# Product Change Notification (PCN)

PCN #: 9F-2021

DATE: 9/27/2021

### 5.2 Shipping Box Label

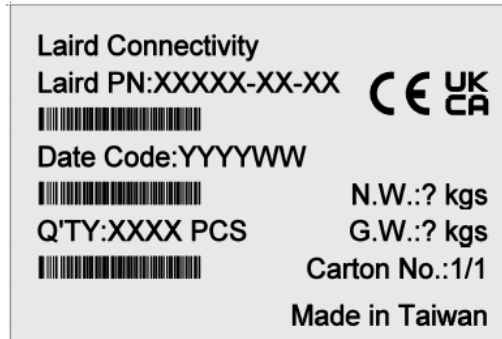
- Unified shipping carton template and added UKCA/CE logo to the label
- This is applicable to all part numbers in this PCN.
